Comments to

**Draft Environmental Impact Statement
for the
Gilberton Coal-to-Clean Fuels and Power Project**

Mike Ewall
1434 Elbridge St
Philadelphia, PA 19149
215-743-4884
catalyst@actionpa.org

February 8, 2006

Cost of WMPI Refinery

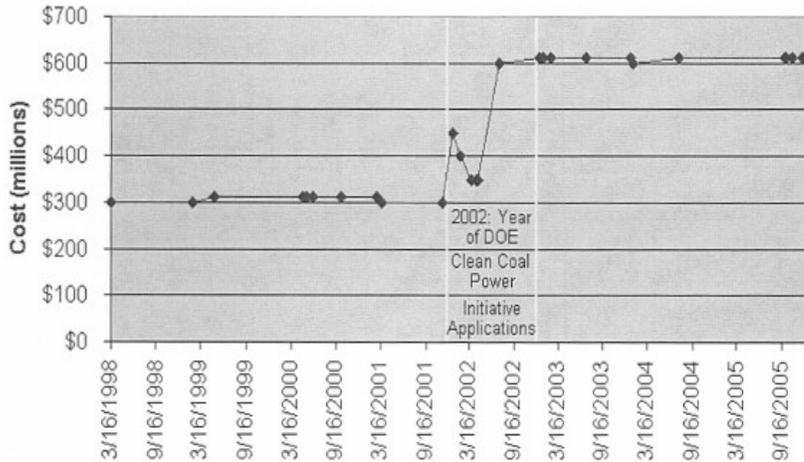
The DEIS states that the decision is whether to fund the project with "\$100 million (about 16% of the total cost of approximately \$612 million)" [xvii]. The projected total cost of the refinery jumped from \$300-312 million to \$612 million in the year that WMPI applied to DOE for this funding. This issue was raised in the scoping comments but went unaddressed in the DEIS.

No explanation has been given for this near-doubling of project costs and it seems that this increase ought to be properly justified so that DOE can assure that no fraud is perpetrated on federal taxpayers and so that the project can be properly evaluated with regard to the 75% cut-off for repayment. The DEIS doesn't mention this 75% cut-off and ought to be clear about how this cut-off affects the applicant's obligation for repayment.

The following chart is based on the stated costs of the refinery in over 30 news articles since 1998. Citations of articles for each data point are available online at: <http://www.ultradirtyfuels.com/projectcost.html>

Revised Section 1.3 notes that DOE's share of the funding for the 3-year demonstration project is expected to be approximately \$100 million, or 10% of the total cost of \$1 billion. Private sector financing and transferable tax credits would provide the remainder of the funds. DOE conducts a thorough analysis of proposed project costs prior to award of a cooperative agreement. WMPI PTY, LLC will be required to provide sufficient evidence that project financing is likely to be available for the entire project and that projected revenues from the facility are achievable and can meet project expenses and debt service requirements. Once awarded, only costs that are allowable under the applicable federal cost principles may be invoiced and shared by DOE.
